# Cooling Design Review

Jack Mills & Matthew Eckhart

# Solutions

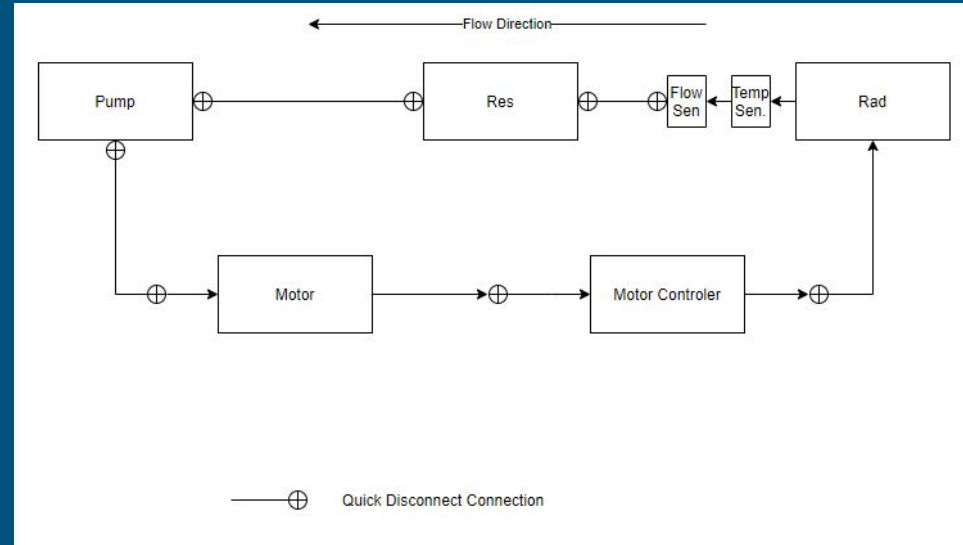
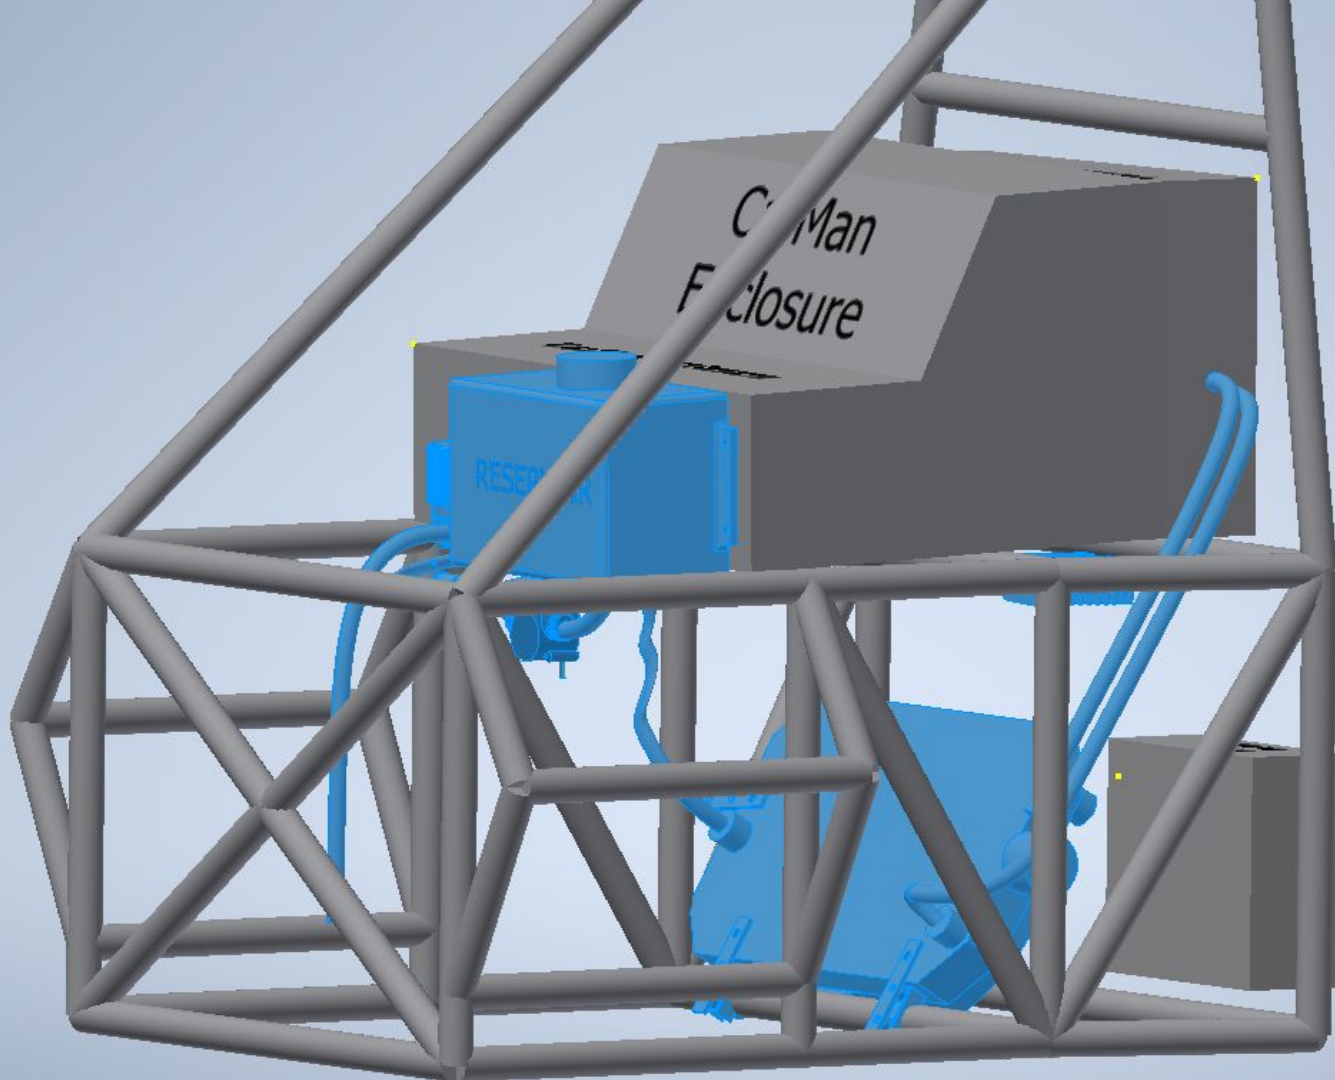
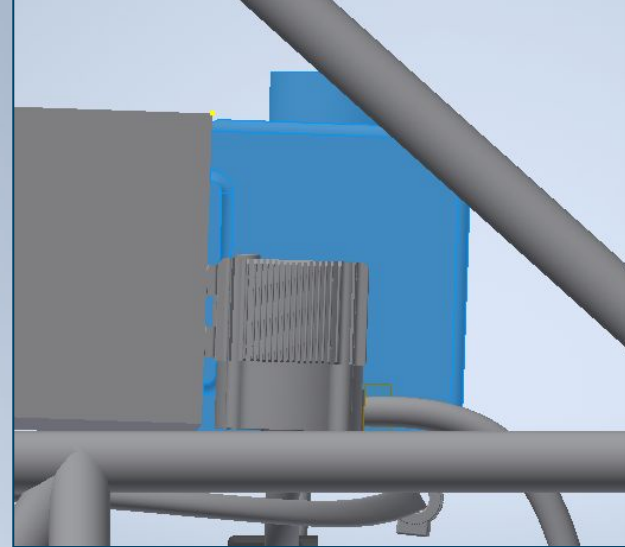
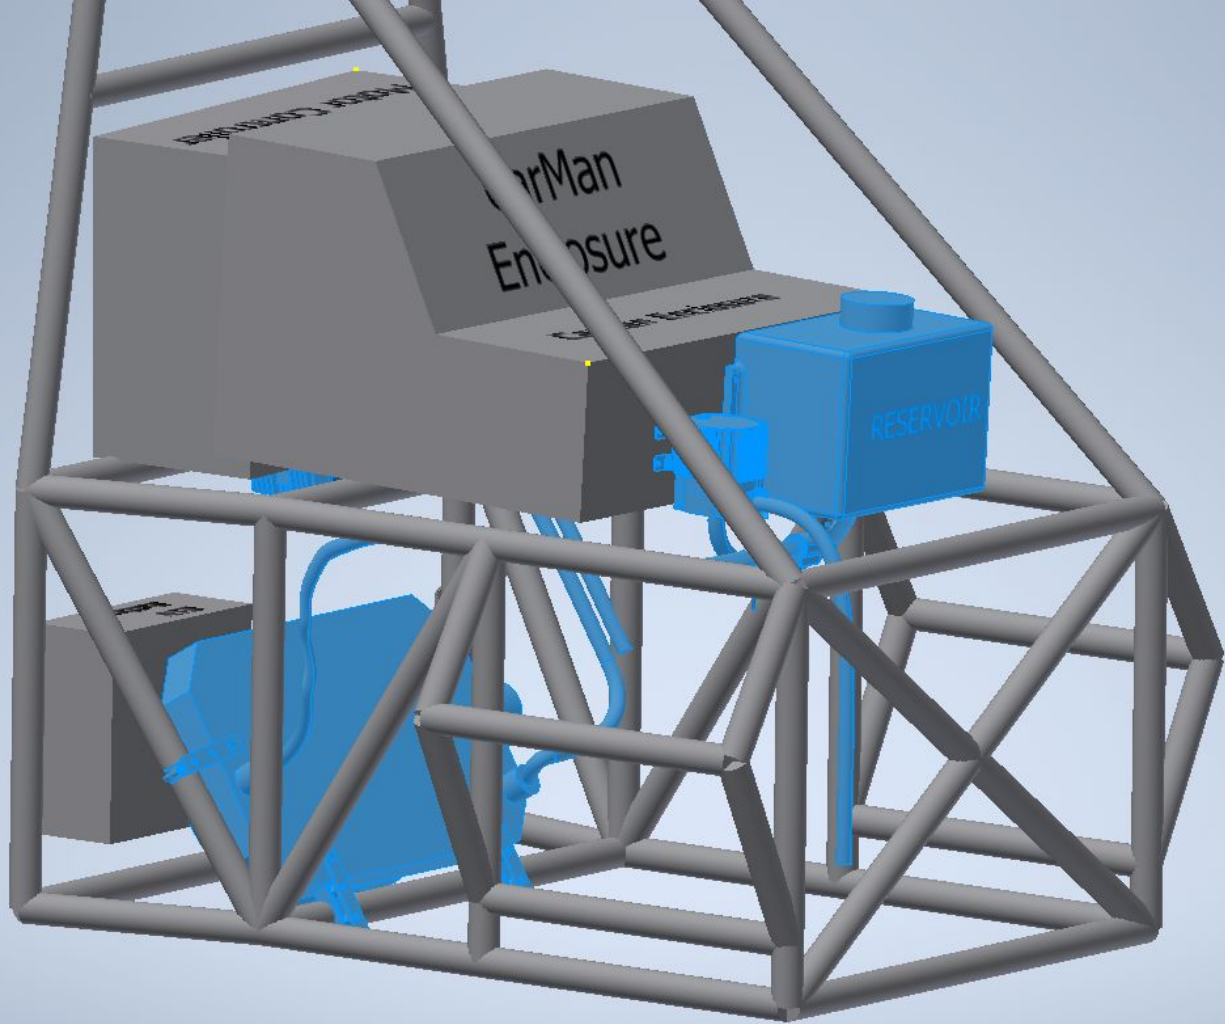
- Mounted directly above main electronics
- Radiator too small?
- Overall heat capacity of system
- Temp sensors mounted on same stretch of cooling line
- No control scheme (always on)

- Increase size of radiator and fan
- Implementation of 2 Qt reservoir
  - Increase time to heat saturation to ~60 seconds
- System components mounted below electronics
- Quick disconnect fittings between major components
- Control scheme planned with TSI

Carri  
Enclosure

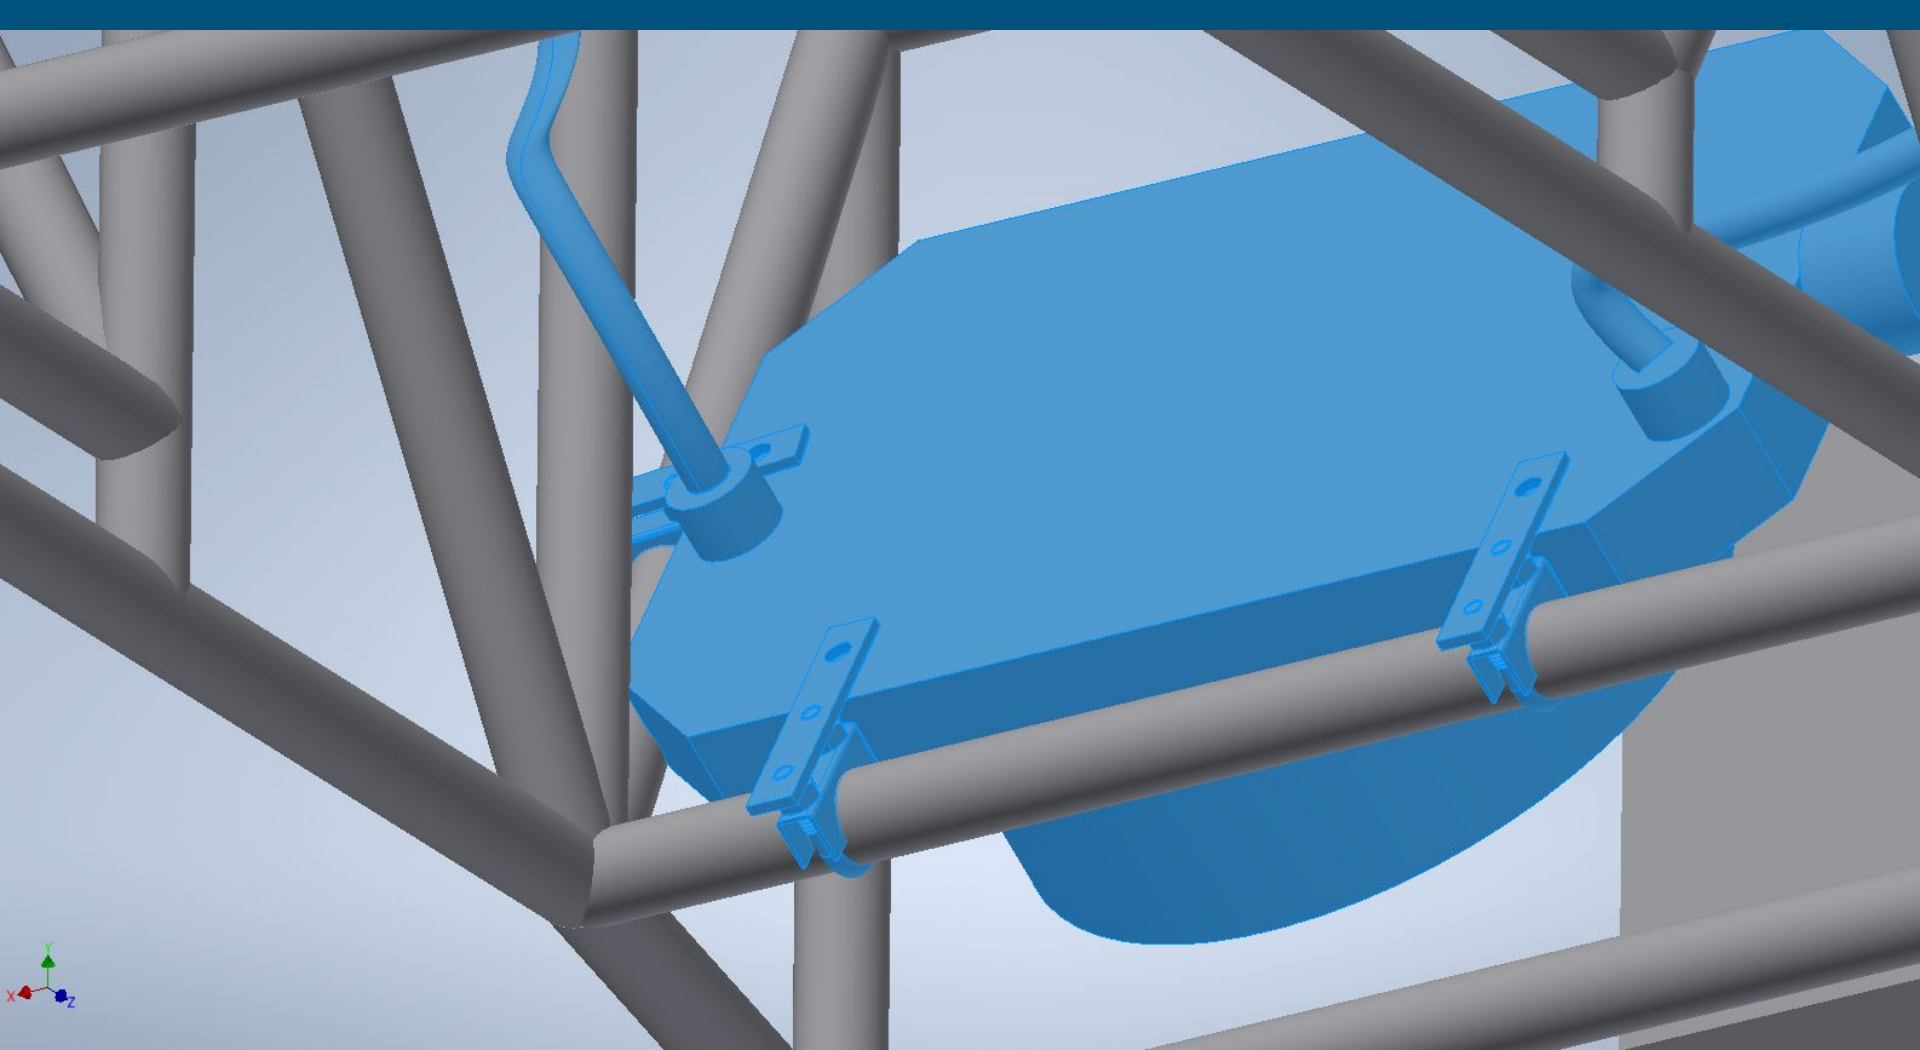
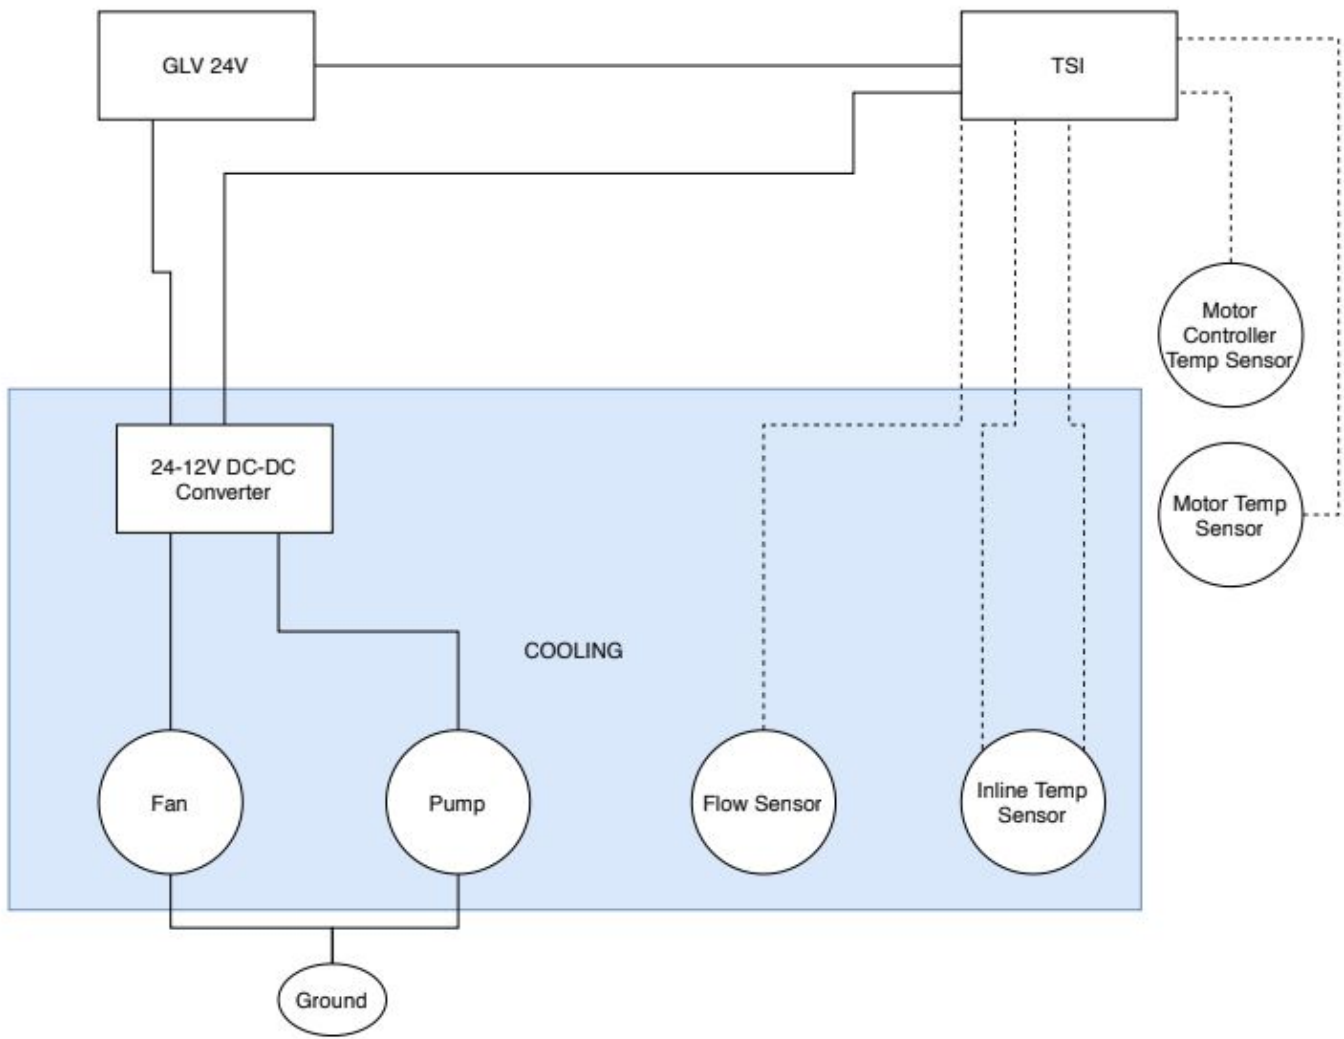
- Enough air intake
- Reservoir not mounted at highest point in system
